**BOROUGH OF LAKE COMO
1740 MAIN STREET
LAKE COMO, NJ 07719**

PLANNING BOARD AGENDA

**NOVEMBER 10, 2025
REGULAR MEETING**

PLOT/GRADING PLAN FOR #3 RIPLEY LANE
 LOT 17 BLOCK 16, BORO OF LAKE COMO
 MONMOUTH COUNTY, NEW JERSEY

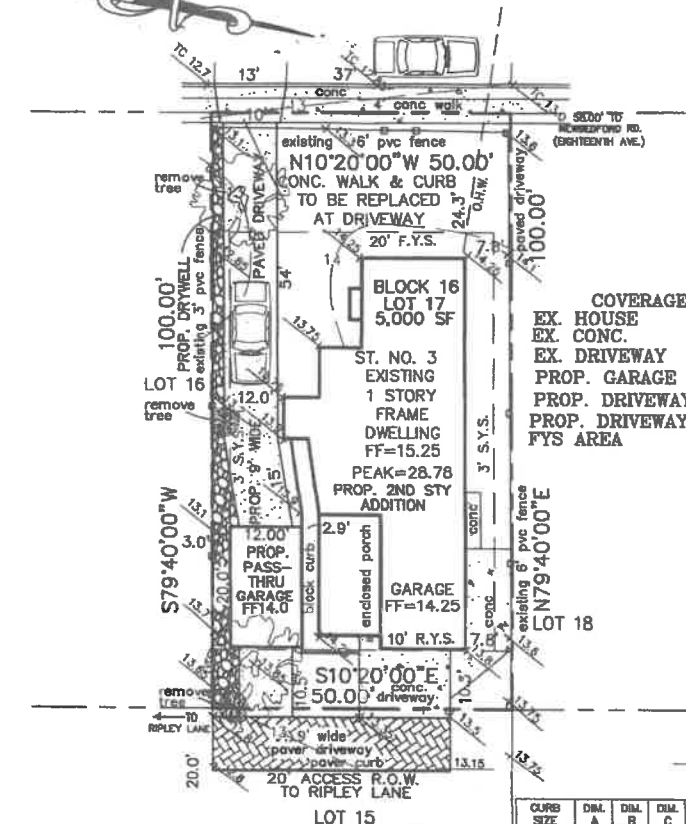
As I believe that this proposal does not create any variance conditions, it is my understanding that the Applicant is seeking to appeal the Zoning Application denial for the new curb cut on Pine Terrace. To this effect, I have conducted a review of the subject property to identify any variances required. My review of the proposed plan identified the following issues that should be addressed through the public hearing process:

1. Ordinance 2024-01 specifies the requirements for drywells and seepage pits for new structures and additions. A drywell is proposed on the Plot/Grading Plan; however, it appears to be established along the surface of the entire southern boundary shared with Lot 16. Ordinance
